To: Ms. Debra Rossi, RPM (USEPA Region III)

From: Theresa Miller, PG, LSP (Golder) and Michele Ruth, PE (RAI)

Date: June 1, 2018

RE: Response to Comments on Work Plan for Additional Investigation
Army Creek Landfill, New Castle County, Delaware

Figure 2.
Existing and Proposed Monitoring Network for ACL Western Lobe Investigation

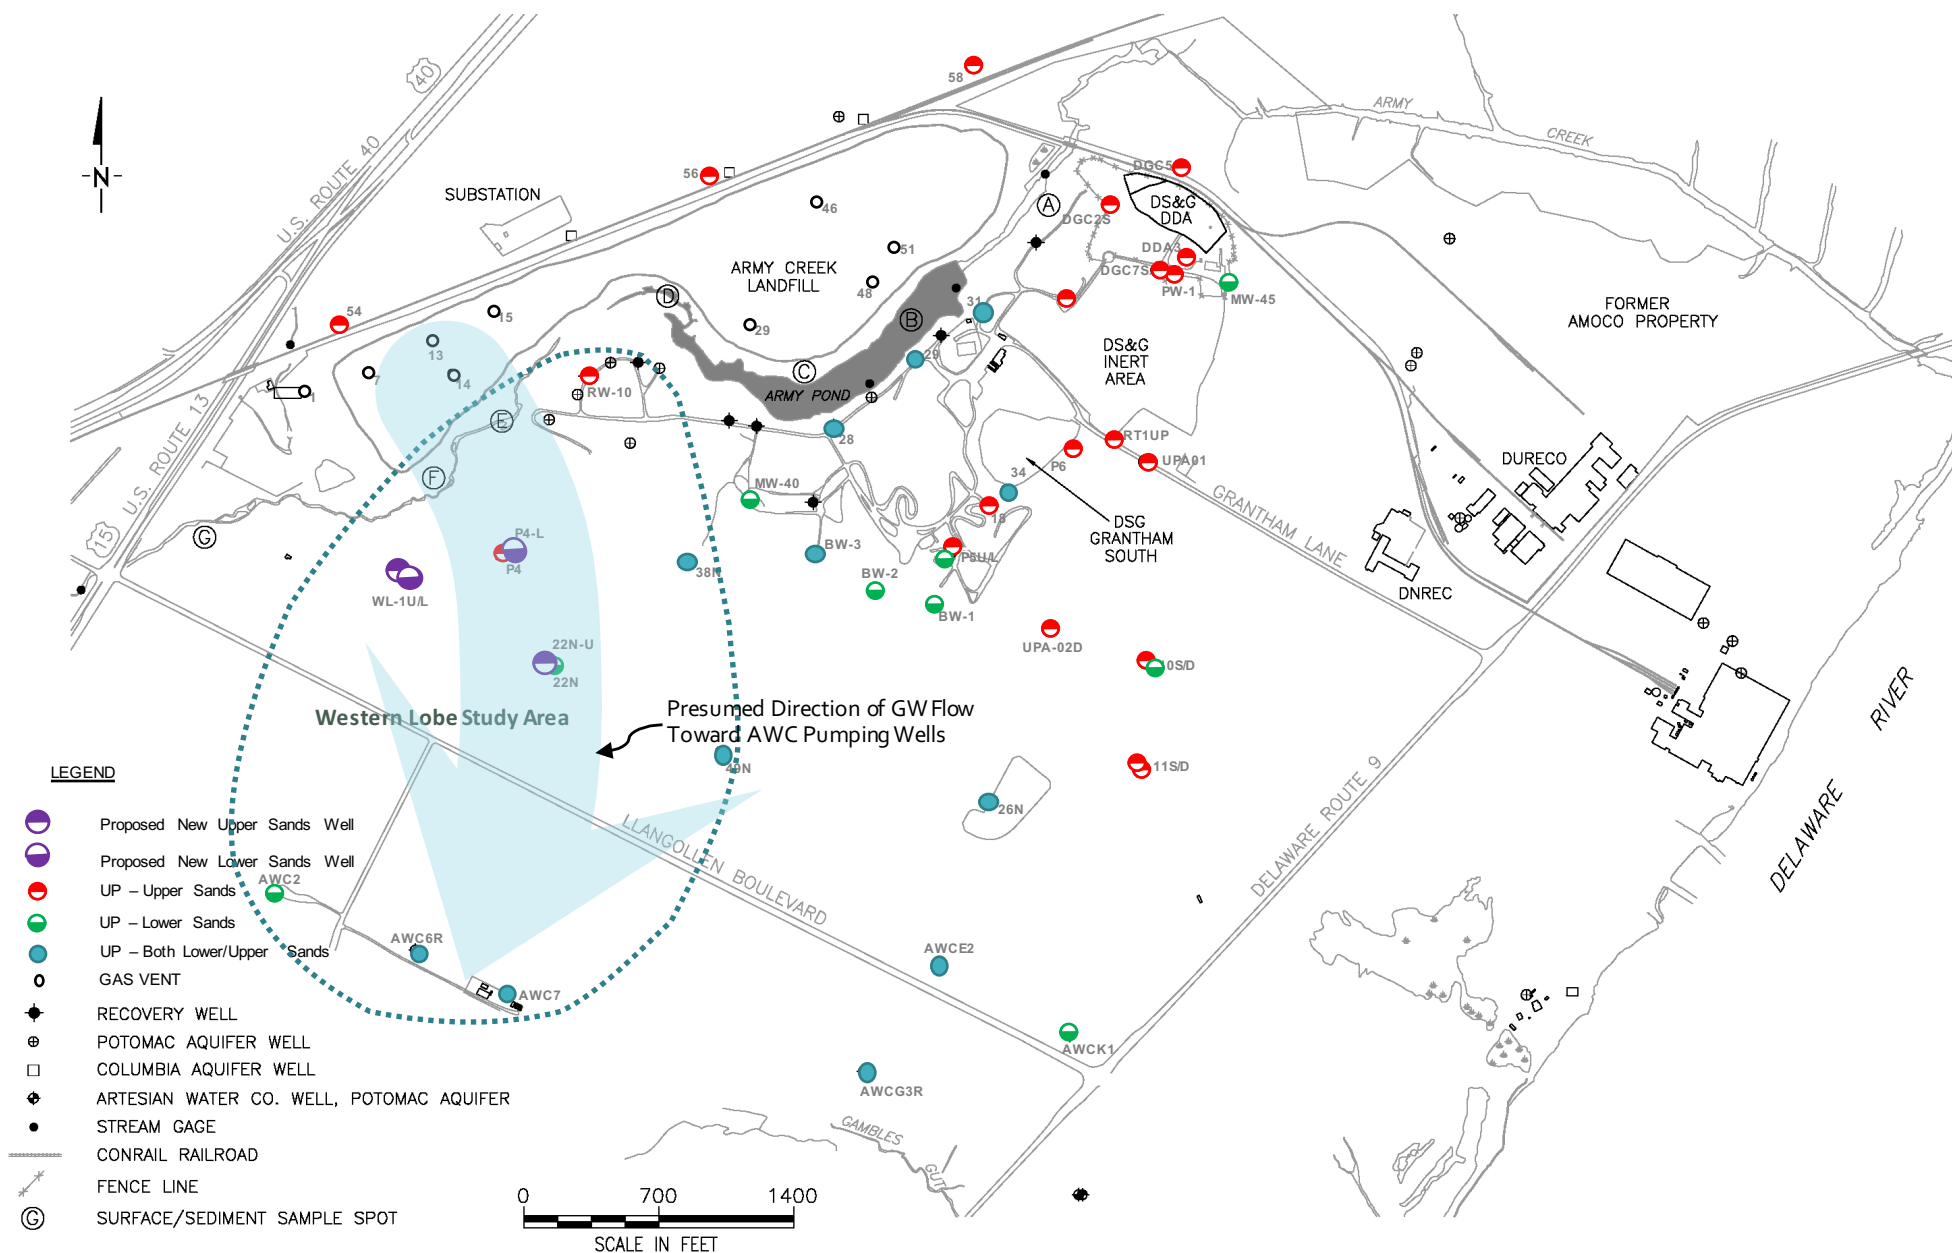
USEPA/DNREC Comment 13. Table 1: Is monitoring well 38N the same well as 38 depicted on Figure 2? Please clarify.

USEPA/DNREC Comment 15. Figures 2 and 4: The gas vents are represented by an assortment of circles, ovals, rings and squares. The same symbol should be used to represent all of the gas vents and the symbol should match the corresponding symbol in the legend.

Yes. The well designation has been changed to 38N on Figure 2. The attached Figure 2 will be included in the revised Work Plan.

As requested, Figures 2 and 4 have been revised; Figure 4 has been re-designated as Figure 6. The attached Figures 2 and 6 will be included in the revised Work Plan.

Figure 5: Western Lobe Area - Groundwater Elevations 2004-2007

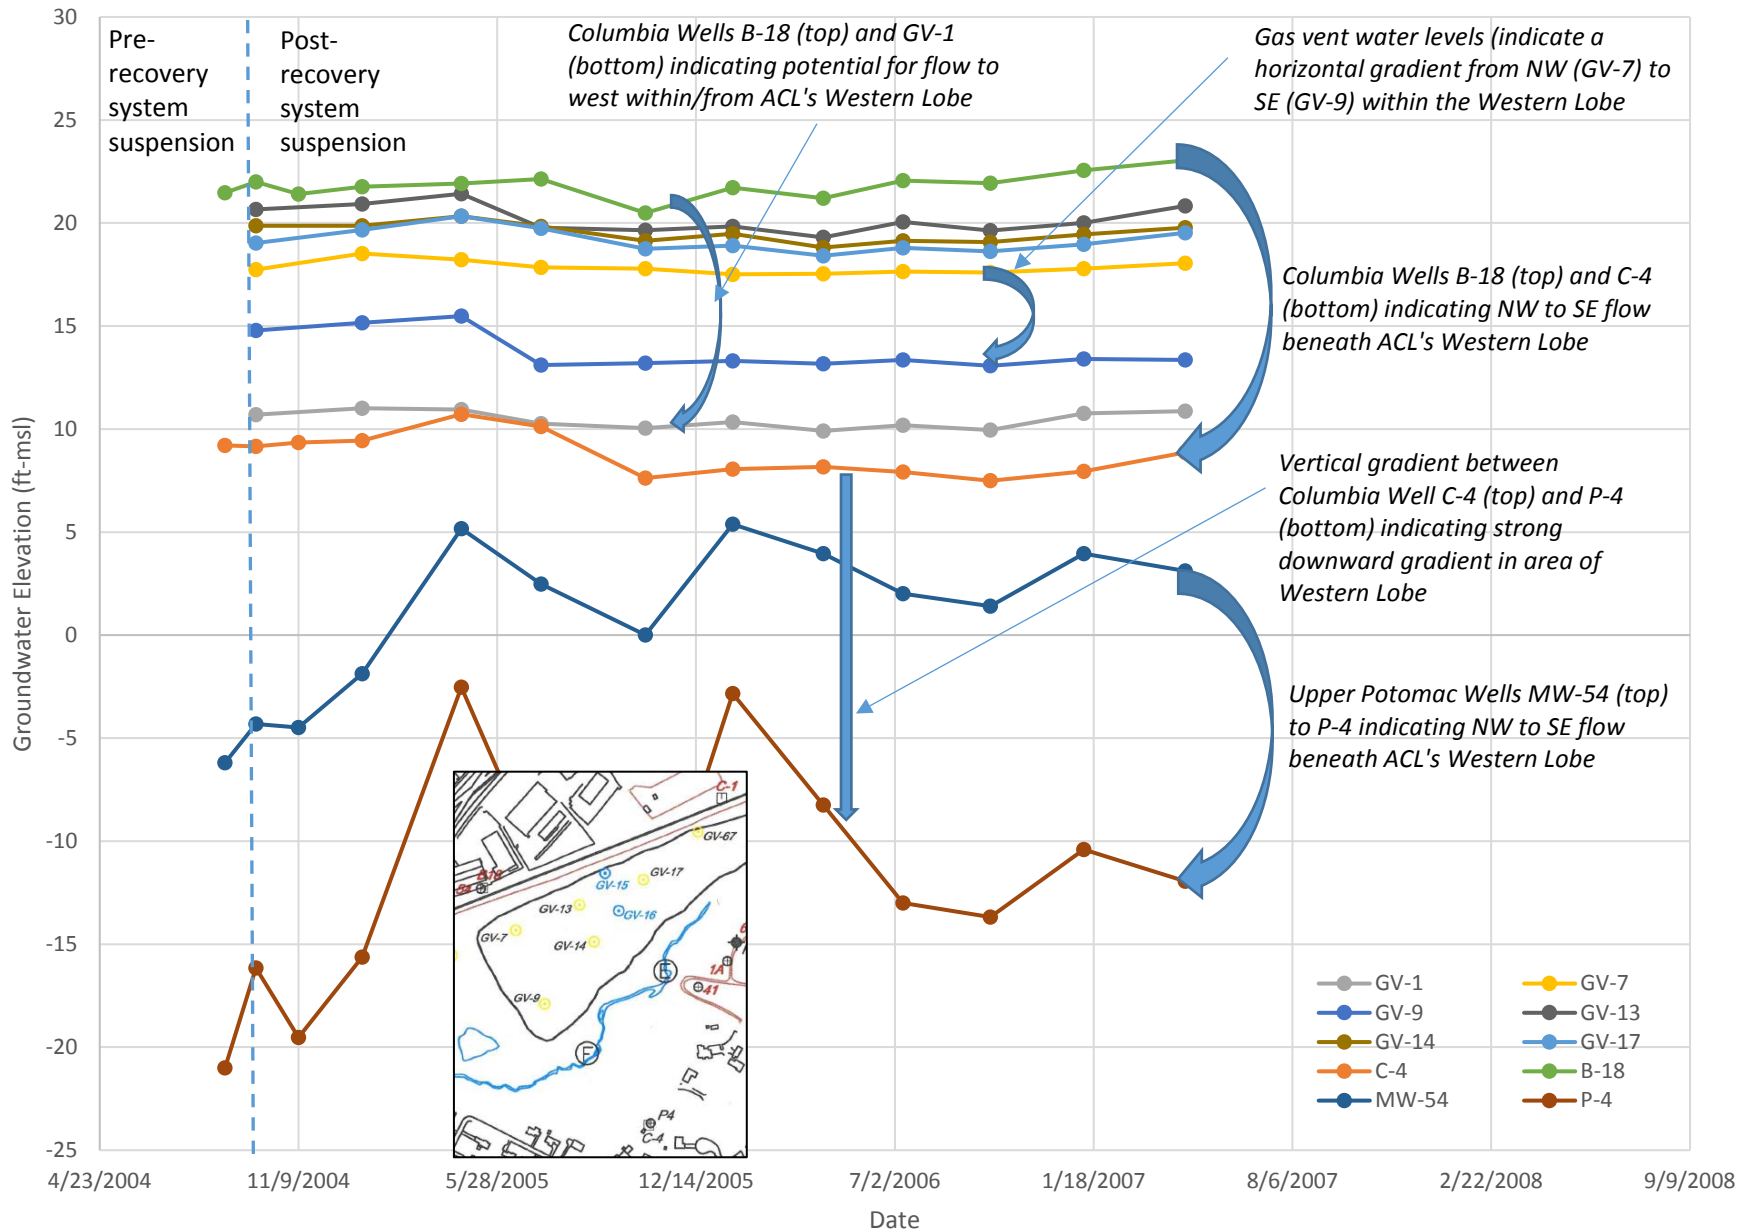
USEPA/DNREC Comment 2. Conceptual Site Model, Hydrogeology: It is reported there that “the Site is located in the up-dip, feather-edge of the Potomac Formation and its stratigraphy is represented by proximal, stream-deposited sands, silts, clays and gravels accumulated in an estuarine, marginal marine basin, with highly variable lateral and vertical distribution of sand, silt,

Although lithologic data is unavailable for locations immediately beneath the landfill itself, water-level data from the Western Lobe gas vents do not show a hydraulic connection between the water within the landfill and the underlying UPA. Water-level data collected by RAI from 2004 to 2007 (see Attachment 3; RAI, 2007), during the pilot suspension of the ACL recovery system, show that the water levels measured in the gas vents were relatively steady and higher than the water levels observed in the nearby Potomac wells, which are influenced by regional pumping from the Llangollen Wellfield (see Figure 4). Columbia water levels for wells outside the landfill during this same period indicate groundwater flows within the Columbia Aquifer from northwest to southeast, and there is a downward gradient from the Columbia Aquifer to the UPA (see Figure 5).

Figure 6.
Locations of Proposed Wells to be included in ACL's PFAS Monitoring Program

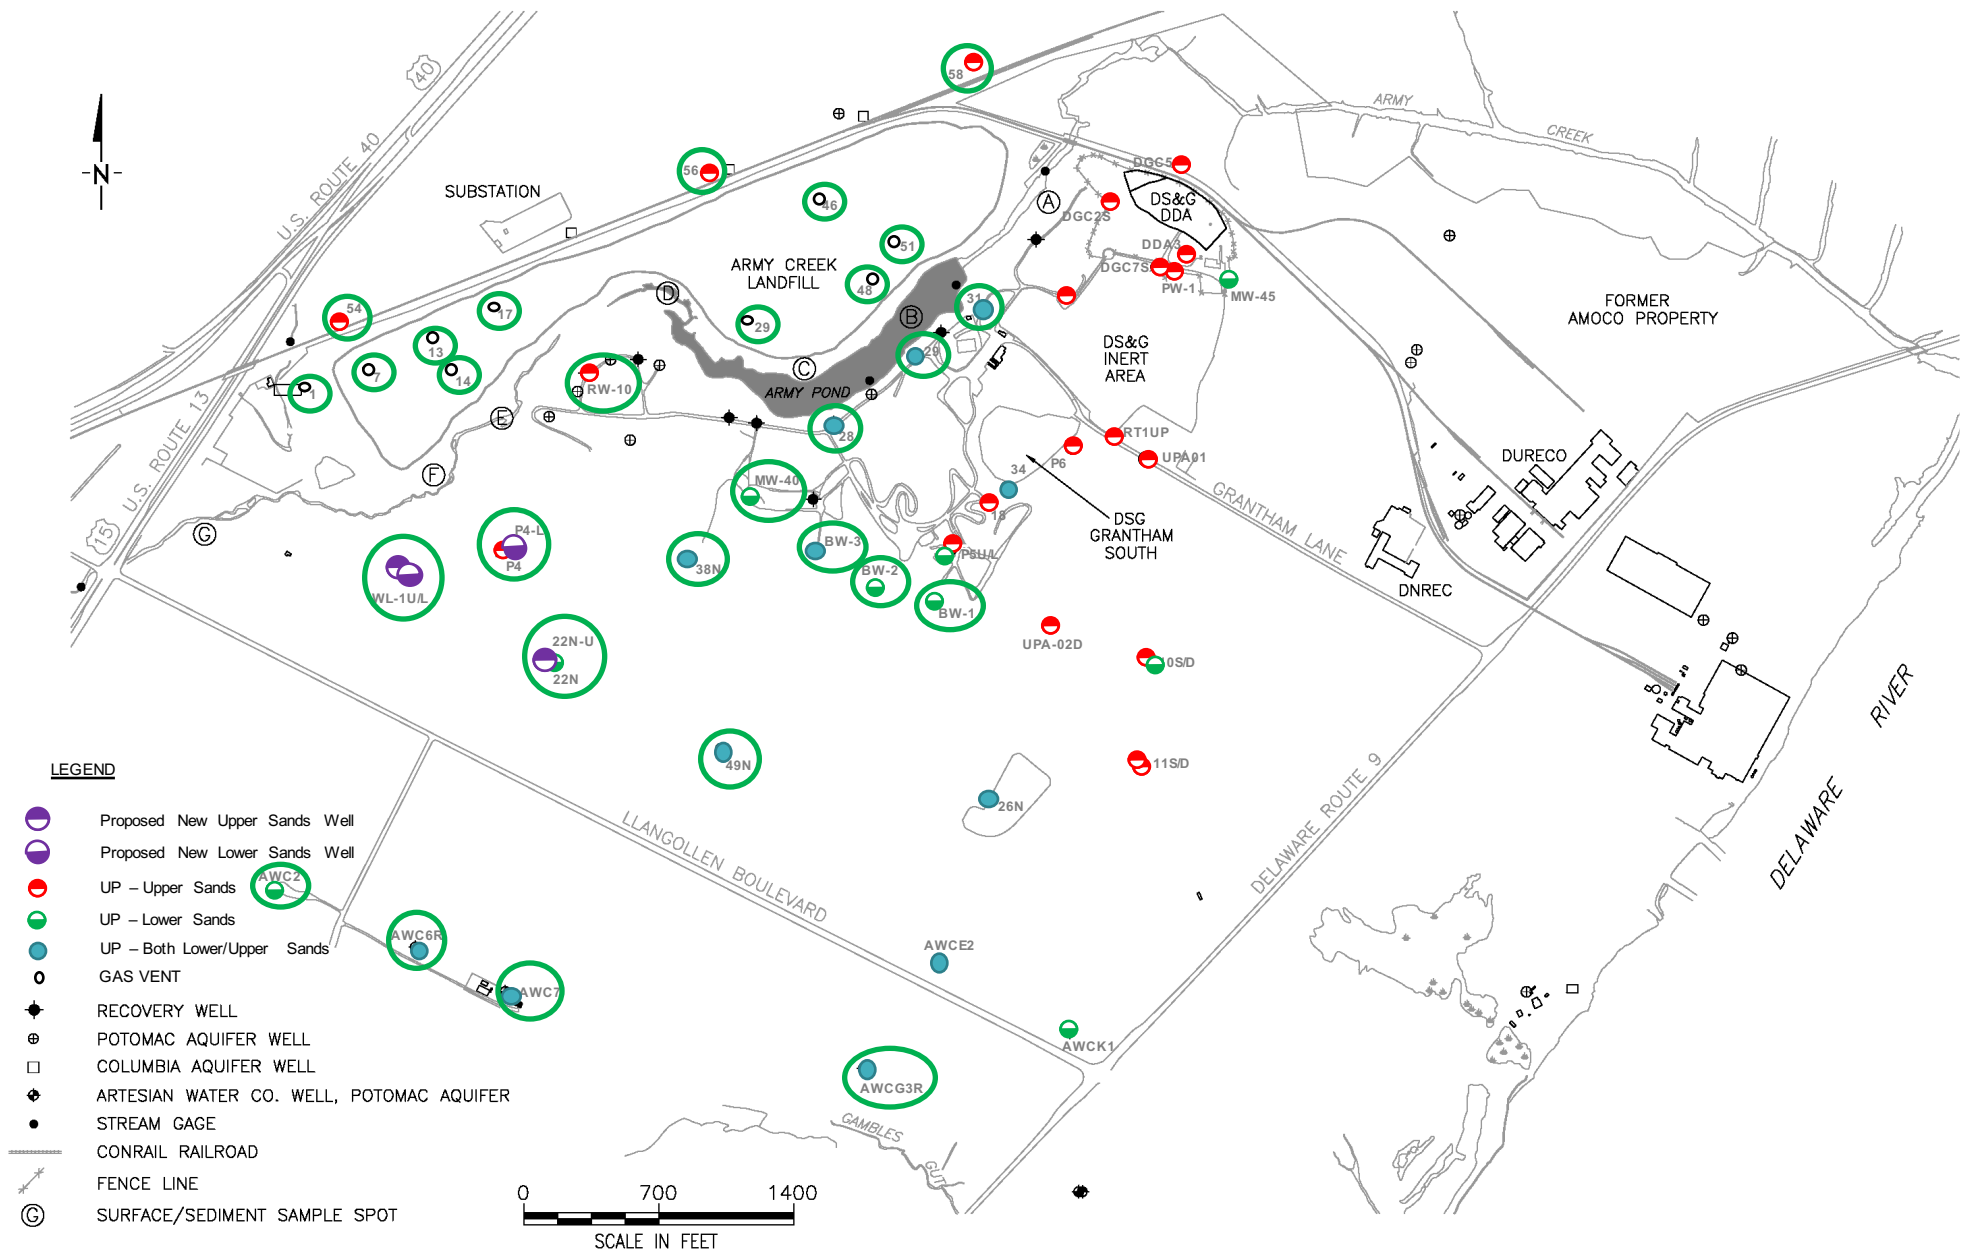
USEPA/DNREC Comment 6. Approaches and Methodologies, Western Lobe Study Area,
first bullet: Artesian wells AWC-2, AWC-6R and AWC-7 are important data points at the south end of the study area as implied in the text of the Work Plan. However, the wells are not identified as sampling points in Table 1 and Figure 4. These wells should be sampled. If they will be sampled under another program (e.g., by Artesian), this information should be provided in the Work Plan, as well as a description of the sampling/analytical methods for the program and an assessment of the data comparability.

As requested, Table 1 and Figure 4 (now designated Figure 6) have been revised to include the locations for wells AWC-2, AWC-6R, and AWC-7. We have also included AWC-G3R in the revised table and figure, which are attached and will be included in the revised Work Plan.
